## **2nd Gen Indoor Station Firmware V2.1.60\_build220815 Release Note (2022-08-23)**

Device Model	DS-KH8350-WTE1、DS-KH8350-TE1、DS-KH6320-WTE1、DS-KH6320-WTE2、DS-KH6320-WTE2(B)、DS-KH6320-TE1、DS-KH8520-WTE1
Firmware Version	V2.1.60_build220815
iVMS-4200 Version	Latest version
Hik-Connect APP	Latest version

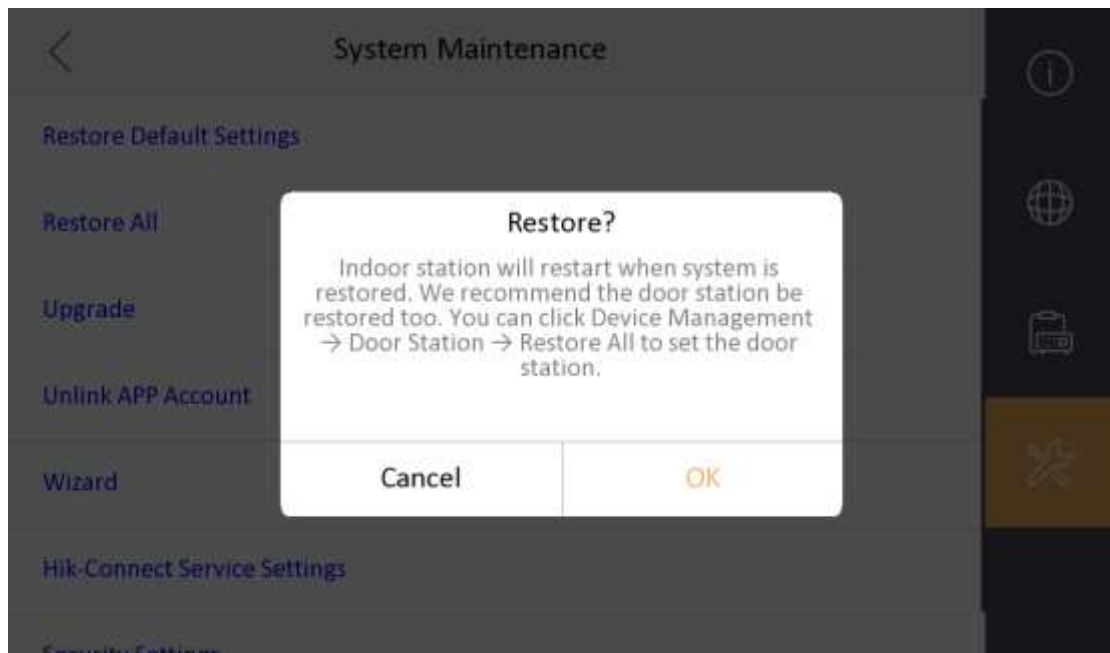
1. Optimizes the maintenance interface with a pop-up window when clicking **Restore** or **Restore All**.

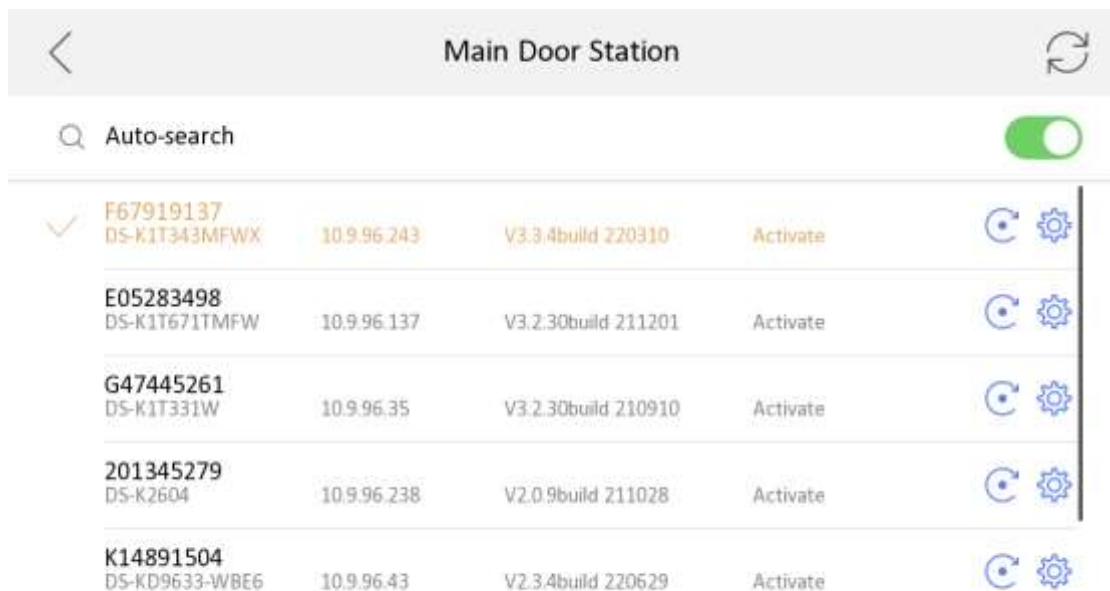
2. Adds the effect of selected door station when relating devices in wizard.

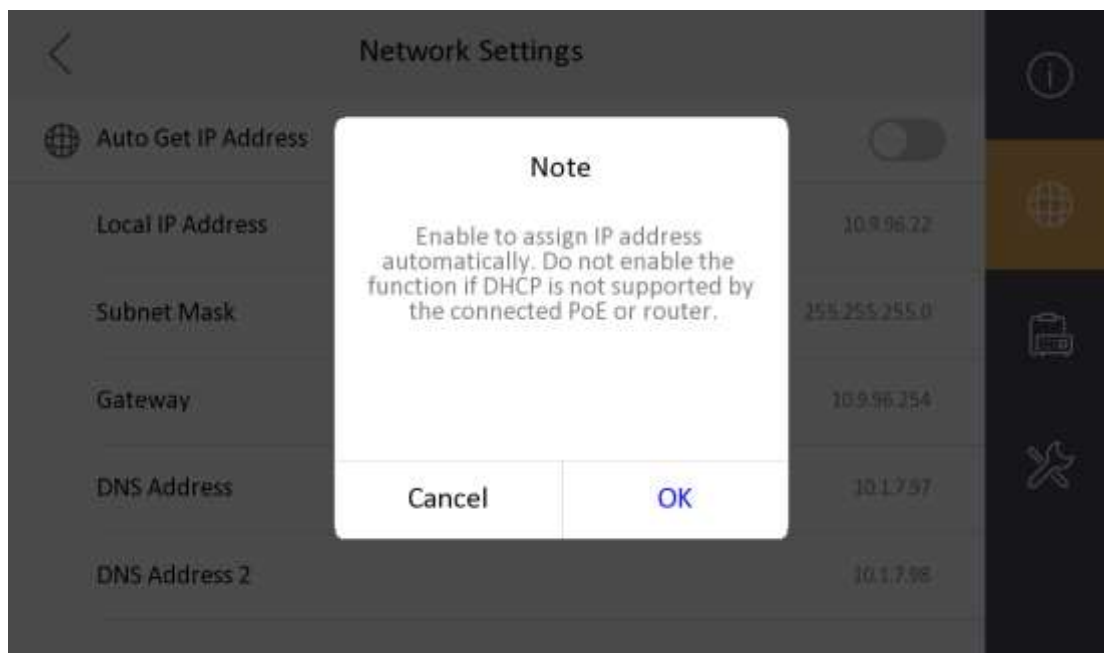
3. Adds a prompt when assigning network IP address automatically.

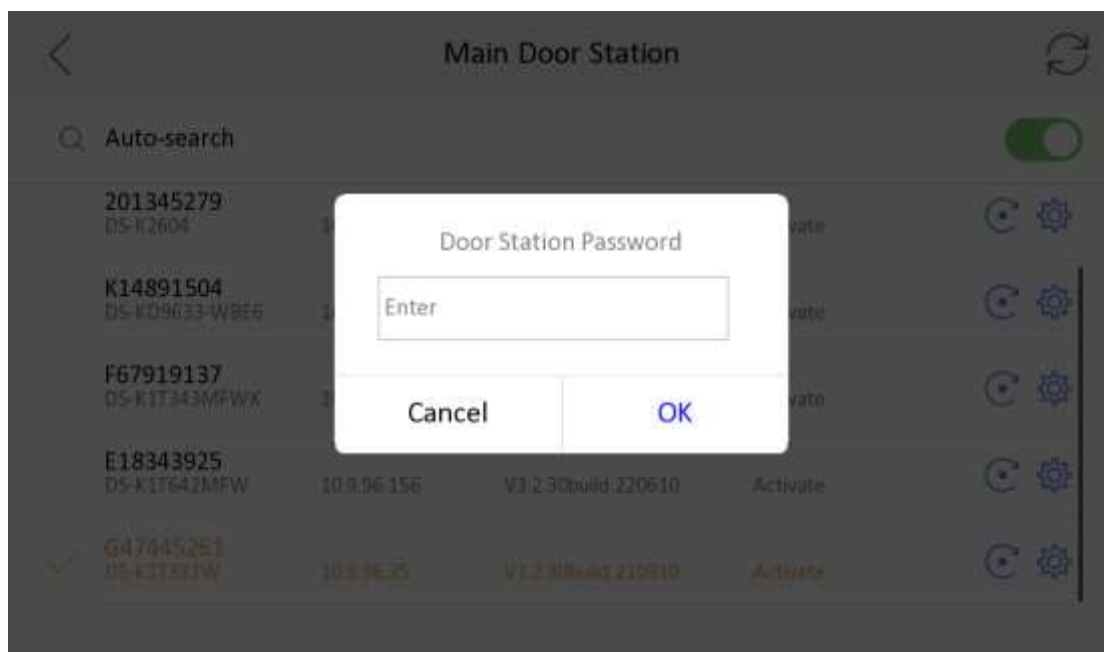
4. In configure wizard to related door station, when the door station password is different from the indoor station, prompt information will pop.

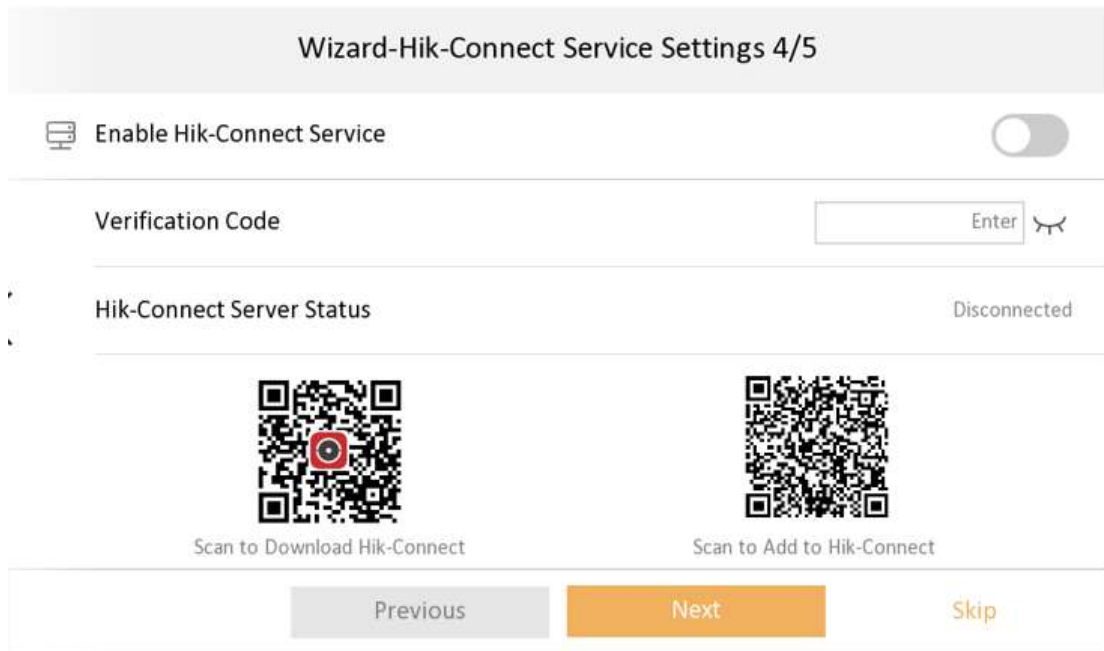
- Optimize registration password settings in Wizard.

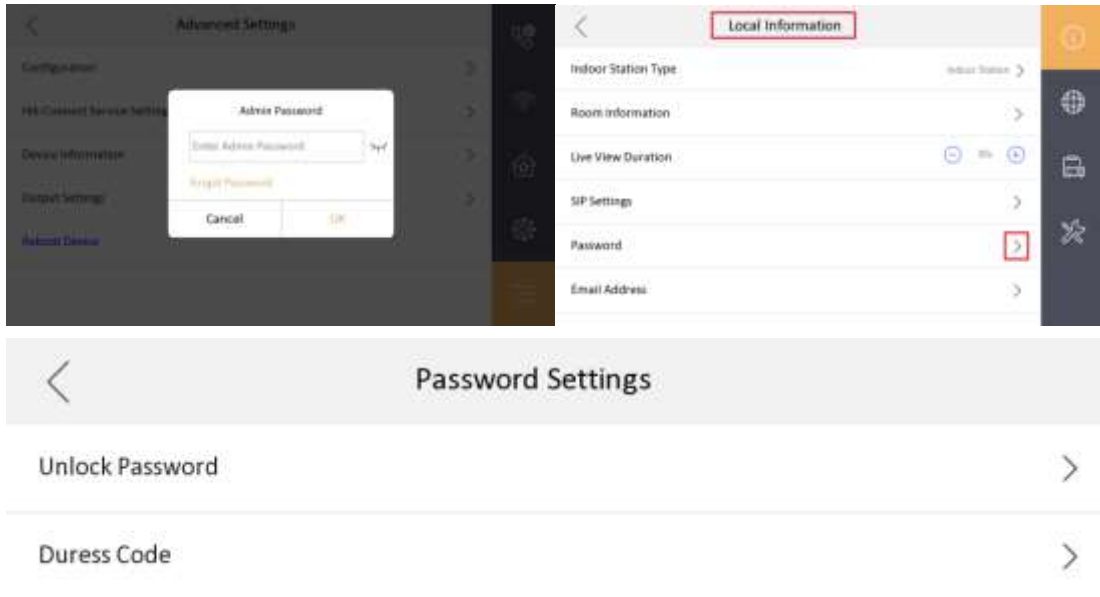
3. Newly added multi-language Croatian, Dutch, Romanian, Czech, Bulgarian, Croatian, Serbian
4. Add IPC interface, when Open Network Video Intercom protocol is selected, add plaintext ciphertext switch menu item configuration

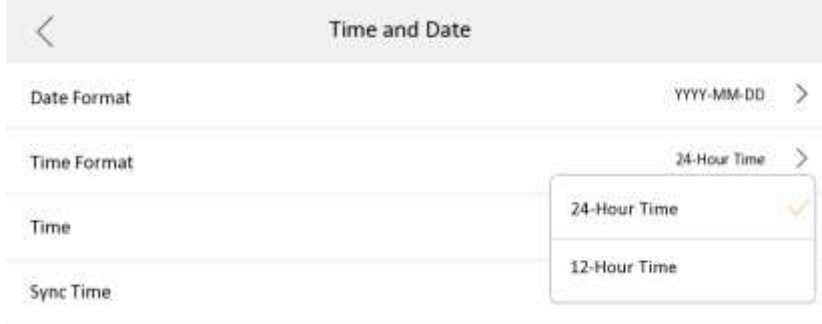
1) Support three formats in Settings->General Settings->Time and Date interface, set year-month-day, day-month-year, month- day - year

2) Support the Settings->General Settings->Time and Date interface, set the 12-hour system, 24-hour system two formats, and the default setting is 24-hour system display.

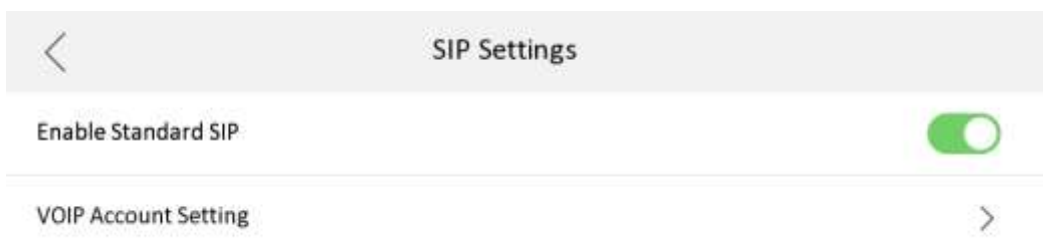
b) The standard SIP of the indoor station is disabled by default, if you want to connect to a third-party standard SIP device, you need to turn on this function.

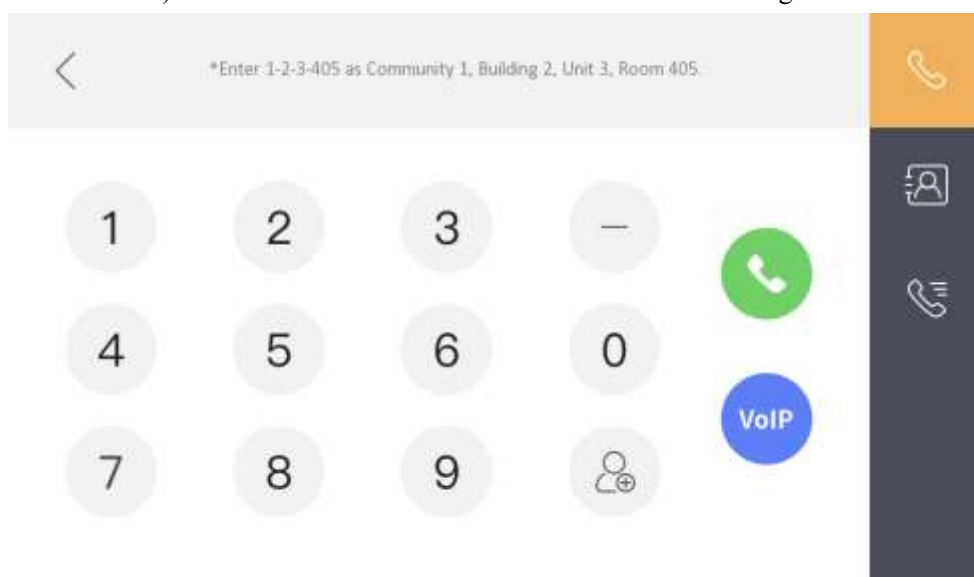
d) Added a VoIP call button in the call interface to distinguish standard SIP calls
